Item Name: Crosstube Turning Detail

DART AEROSPACE LTD		Work Order:	27562
Description: Crosstube Assembly (205/212/412 High Fwd)		Part Number:	D212-664-141
Inspection Dwg: D212-664-141 Rev: D		Page 1 of 2

DRAWING NO. D212-664-141	TITLE XTUBE ASSY (205/212/412 HI FWD)	REV. D	DART AEROSPACE LTD ENGINEERING ORDER		D.E.O. NO. D212-664-141-D-1	SHEET NO. SHEET 1 OF 2	SCALE NTS
DRAWN	CHECKED	UP	MFG. APPR.	APPROVED	DE APPR.		
DATE 11.04.07	DATE 11.04.11		DATE 11.04.12	DATE 11/04/12	DATE 11.04.12

DRAWING NO. D212-664-141	TITLE CROSSTUBE ASS'Y (205 HI FWD)	REV. D	DART AEROSPACE LTD ENGINEERING ORDER		D.E.O. NO. D212-664-141-D-2	SHEET NO. SHEET 1 OF 1	SCALE NTS
DRAWN <i>UP</i>	CHECKED <i>ADS</i>	MFG. APPR. <i>DS</i>	APPROVED <i>MD</i>	DE APPR. <i>HH</i>			
DATE 11.07.15	DATE 11.07.20	DATE 11.07.21	DATE 11/07/21	DATE 11.07.21

**D212-664-141/-141B
ASSEMBLY DETAIL**

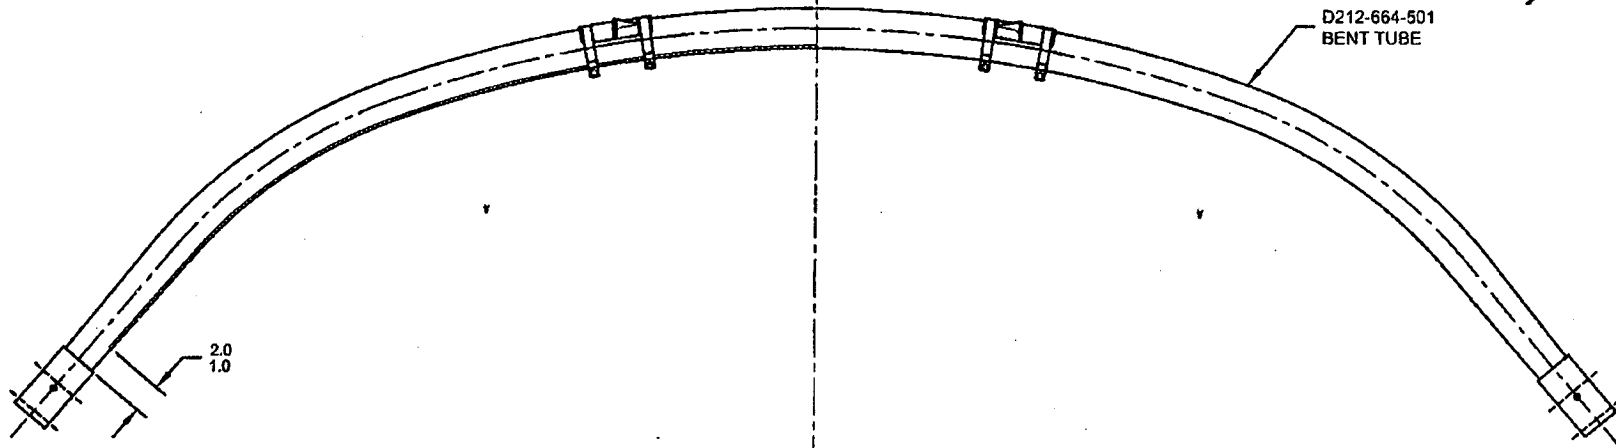
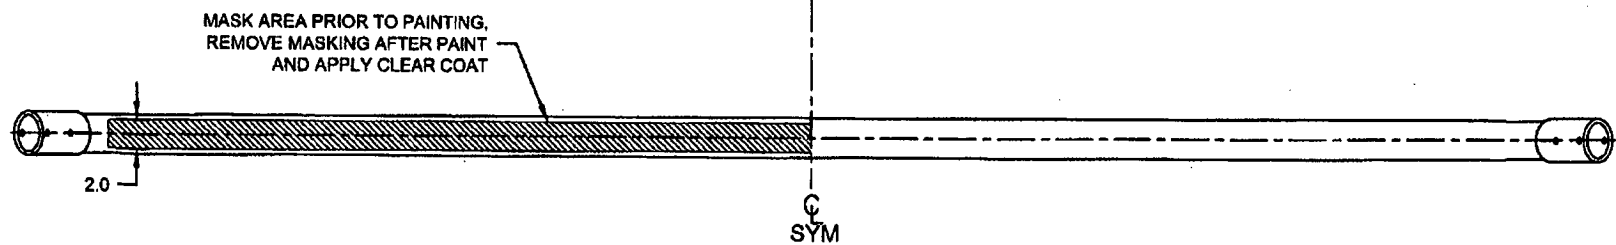
PURPOSE:

ADD AN INSPECTION WINDOW TO UNDERSIDE OF CROSSTUBE.

NOTES 2 OF SHEET 1 IS AMENDED AS FOLLOWS:

IS:

- 2) FINISH: CHEMICAL CONVERSION COAT PER DART QSI 005 4.1
PRIME INSIDE AND OUTSIDE PER DART QSI 005 4.2
MASK UNDERSIDE OF CROSSTUBE AS SHOWN (HATCHED AREA) AND
PAINT OUTSIDE PER DART QSI 005 4.2
REMOVE MASKING AND APPLY CLEAR COAT

WAS:

- 2) FINISH: CHEMICAL CONVERSION COAT PER DART QSI 005 4.1
PRIME INSIDE AND OUTSIDE PER DART QSI 005 4.2
PAINT OUTSIDE PER DART QSI 005 4.2
